Appendix L: Rebecca Morris expert review comments

From: [Rebecca Morris](#)
To: [Shannon Watson](#)
Subject: RE: Eastern Bays Shared Path piling and excavation and potential effects on Waiwhetu aquifer
Date: Wednesday, 7 October 2020 2:03:37 PM
Attachments: [image010.png](#)
[image011.png](#)
[image012.png](#)
[image013.png](#)
[image014.png](#)

Lowry Bay

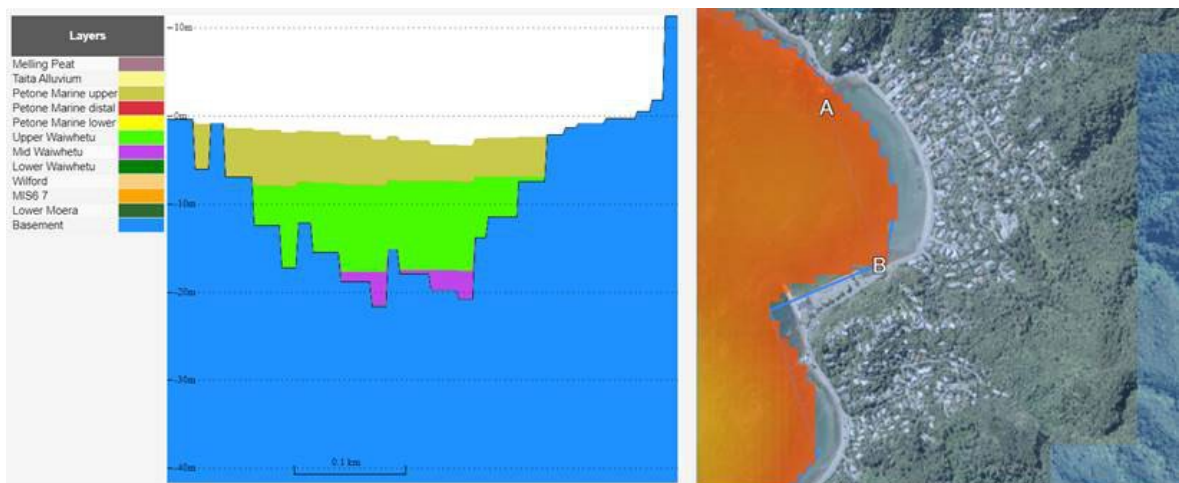
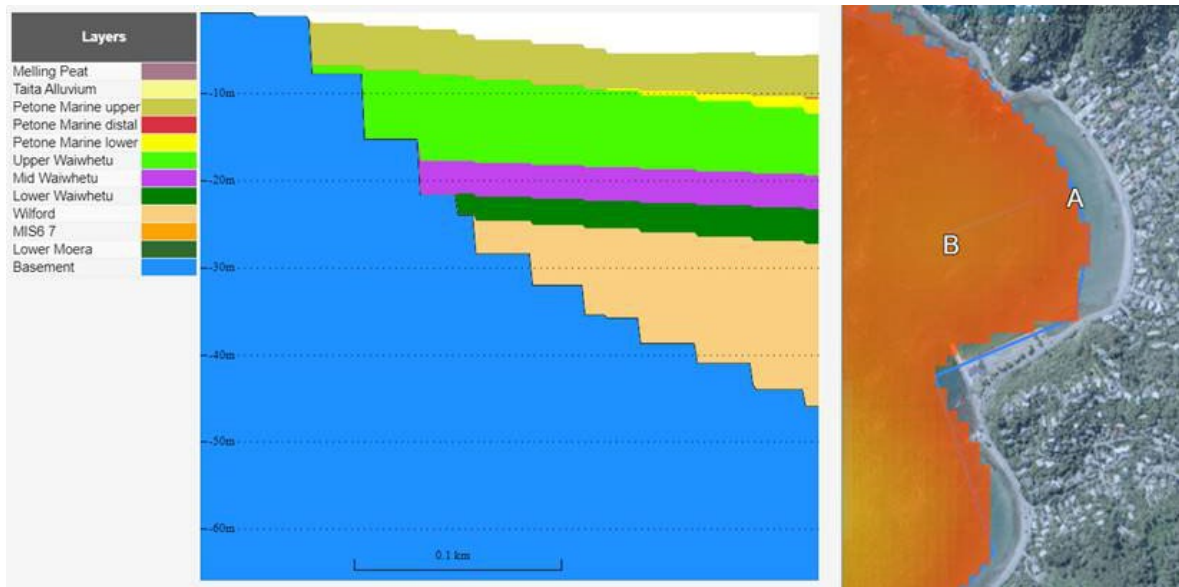
I had a look at the 3D geological model at the bays mentioned below. Of the four bays mentioned, Lowry Bay is the only one that jumps out that may be an issue. I've attached the screenshot of the cross sections below. I'm unsure if the model is slightly offset from the aerial photograph, as it does not appear to go right up to the road.

You can see that the Waiwhetu is encountered around the 7 m mark and is overlain by Petone marine sediments. In the CMMP we need to ensure that no leakage occurs in this area. We should include the double casing methodology that we use for drilling/piling in the Hutt Valley in the CMMP. Are you familiar with this?
